**PLANNING COMMITTEE REPORT**  
**Tuesday 18 August 2020**

<b>APPLICATION FOR CONSIDERATION:</b>	<b>DAWLISH - 20/00922/LBC - Dawlish Railway Station , Station Road - Works to include reconstruction of existing timber downside station platform, new accessible passenger footbridge, alterations to existing platforms surface resulting in minor changes to door openings of downside station building, refurbishment of passenger waiting room and refurbishment and repairs to the fabric of the station building on seaward elevation all in association with Dawlish Sea Wall Stage 2 project</b>	
<b>APPLICANT:</b>	<b>Mr Colin Field</b>	
<b>CASE OFFICER</b>	<b>Helen Addison</b>	
<b>WARD MEMBERS:</b>	<b>Cllr Linda Goodman-Bradbury Cllr Linda Petherick Cllr Martin Wrigley</b>	<b>Dawlish North East</b>
<b>VIEW PLANNING FILE:</b>	<a href="https://www.teignbridge.gov.uk/planning/forms/planning-application-details/?Type=Application&amp;Refval=20/00922/LBC&amp;MN">https://www.teignbridge.gov.uk/planning/forms/planning-application-details/?Type=Application&amp;Refval=20/00922/LBC&amp;MN</a>

20/00922/LBC - Dawlish Railway Station,  
 Station Road,  
 Dawlish,  
 EX7 9PJ

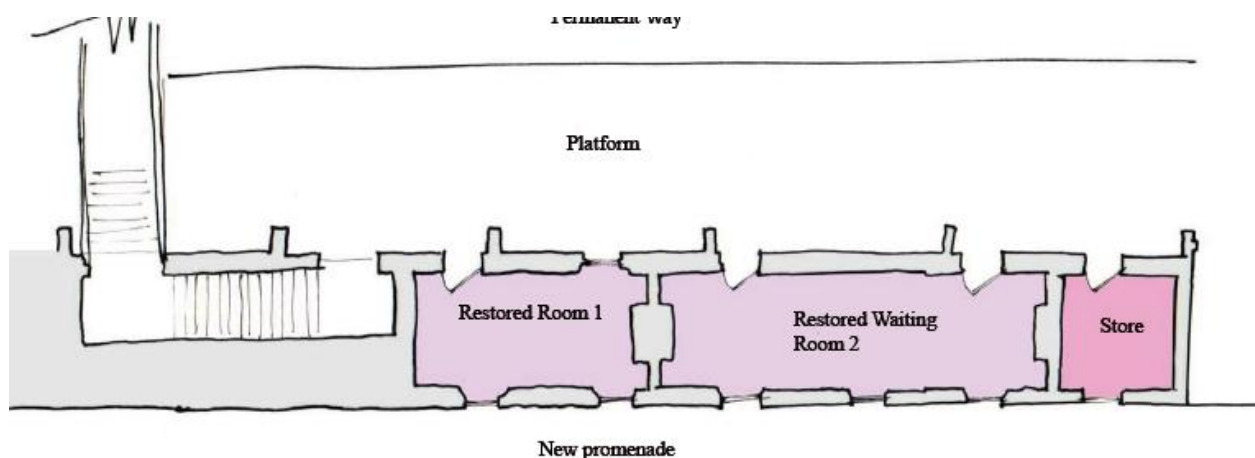
3.24 Externally the render to the seaward elevation would be reinstated.

3.25 In their response to the Council's conservation officer NR have stated the intent of the application is that *at least one waiting room will be brought back into use as part of this project and it is agreed that a full specification for the works to the waiting room, including a condition survey, drawings and scheduled would be required.* This is at odds with the description of proposed works of reinstatement in appendix C of the Heritage Statement which details that all the rooms will be restored and includes this plan:

3.26 It is important that NR confirm that the restoration works extend to all the rooms in the downside building as this is a clear heritage gain that should be secured through the grant of consent. This point is supported by HE in their second consultation response.
